# Access Compliance Report

## Public Rights-of-Way

Intersection ID: 11313	Main Street: STAFFORD_DR	Cross Street: WILKINSON_BV	Location: NW
ADA ID: 8D803B25B37C	Ramp Type: Perp	Initial Pass/Fail: Fail	Overall Compliance: No
		Severity Score: 8.75

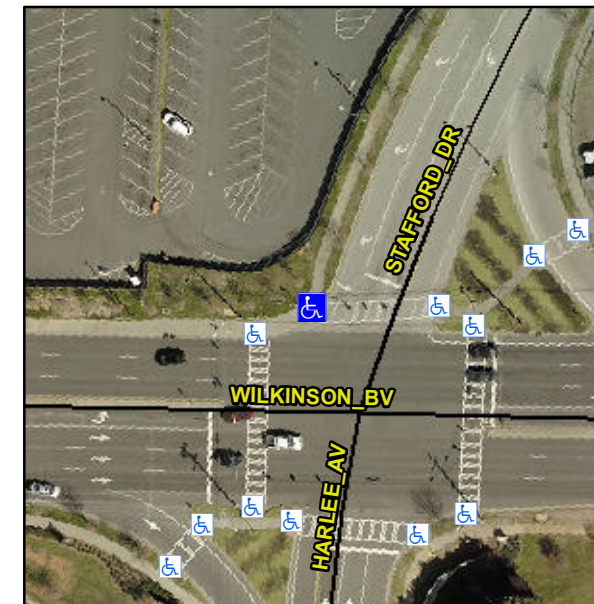
**Not Found, R304.5.1**

Compliance	Description	Data	Compliance	Description	Data
N/A	Ramp Length (in)	96.0	Yes	Ramp Slope (%)	6.6
No	Ramp Width (in)	47.0	Yes	Ramp XSlope (%)	1.0
N/A	Flare Type LT	N/A	N/A	Flare Type RT	N/A
N/A	Flare Slope LT (%)	N/A	N/A	Flare Slope RT (%)	N/A
N/A	Flare Traversable LT?	N/A	N/A	Flare Traversable RT?	N/A
N/A	Landing Length (in)	N/A	N/A	DWS Provided?	N/A
N/A	Landing Width (in)	N/A	N/A	DWS Contrast?	N/A
N/A	Landing Slope (%)	N/A	N/A	DWS Length (in)	N/A
N/A	Landing X Slope (%)	N/A	N/A	DWS Full Width?	N/A
N/A	Landing Curb? (Y/N)	N/A	N/A	DWS Offset (in)	N/A
N/A	Shared Landing?	N/A			
N/A	Gutter Ponding?	N/A	N/A	Gutter Slope (%)	N/A
N/A	Gutter Lip Ht (in)	N/A	N/A	Gutter X Slope (%)	N/A
N/A	Painted X Walk1?	Yes	N/A	Painted X Walk2?	N/A
	X Walk 1 Direction	To E		X Walk 2 Direction	N/A
N/A	X Walk 1 Width (in)	111.0	N/A	X Walk 2 Width (in)	N/A
	X Walk 1 Slope (%)	1.6		X Walk 2 Slope (%)	N/A
	X Walk 1 X Slope (%)	1.3		X Walk 2 X Slope (%)	N/A

**Remove & Replace Entire Ramp.**
